SERVICE DIRECTIVE BULLETIN NO. 0077

Revision C

1. SUBJECT: Tail Rotor Spindle, Enstrom P/N 28-150064-11 and -13 Life Limit Addition
2. MODEL:    F-28F, 280F and 280FX Models, and any F-28C, F-28C-2 or 280C Models that have been converted to use the 28-150064-11 or -13 spindle
3. EFFECTIVITY: As addressed in Paragraph 2, Model, and in Paragraph 5, Compliance
4. BACKGROUND:

Figure 1: Areas of tail rotor spindle which require particular attention during pre-flight inspection.

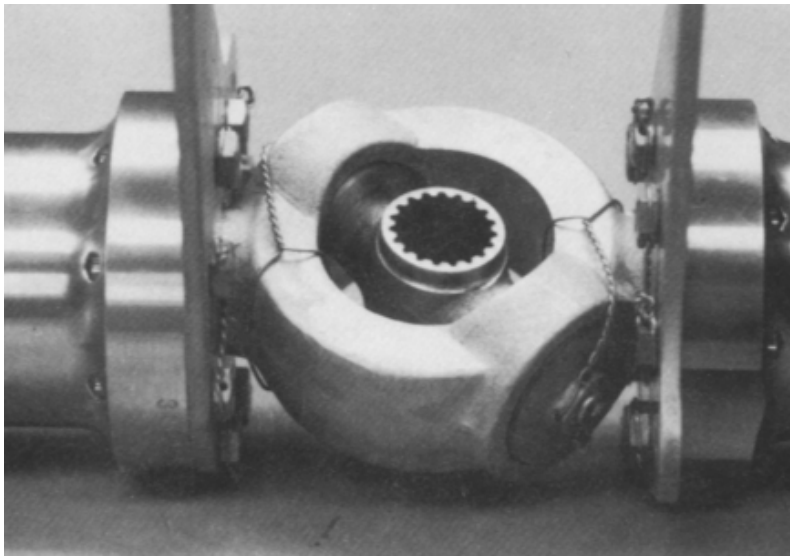
Conduct a close visual inspection for cracks in the area around the teeter bearing bores (see Figure 1). Any spindles found cracked must be removed and replaced with an airworthy component prior to the flight.

5.3.6 Thoroughly clean spindle in the suspect area to the dye penetrant manufacturer's recommendations. See Figure 1.

Figure 2: New safety wire method for teeter bearing cap retention.

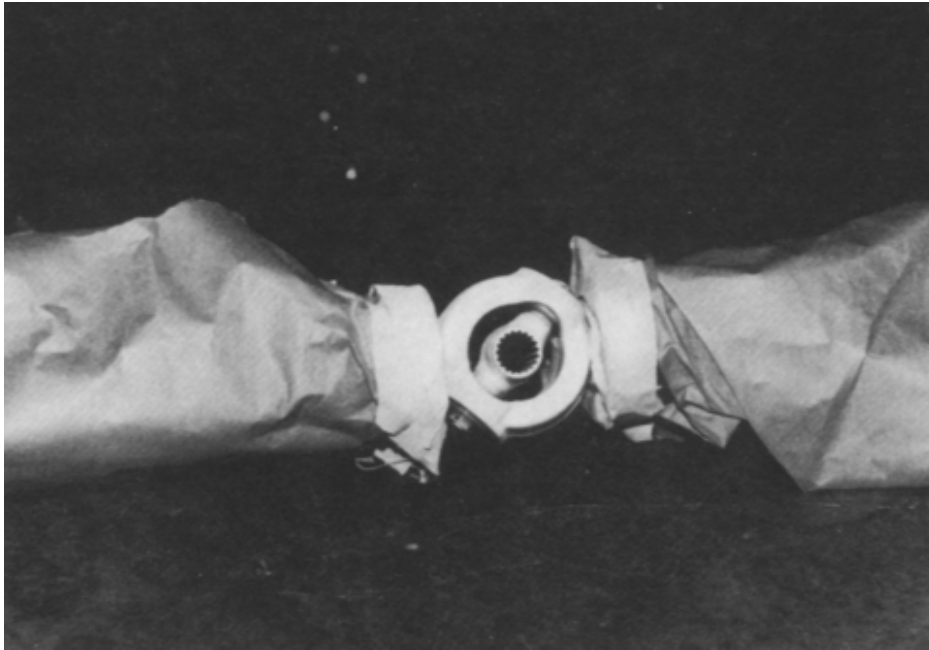
5.3.9 After completion of the inspection, the bearing caps on the 28-150064-11 spindles must be re-safetied as illustrated in Figure 2. This illustration indicates the repositioning of the safety wire on the spindle which will allow an unobstructed view of the area to be inspected.

5.4 The tail rotor can now be reassembled and the teeter bearing caps safetied per Figure 2 (28-150064-11 spindles only).
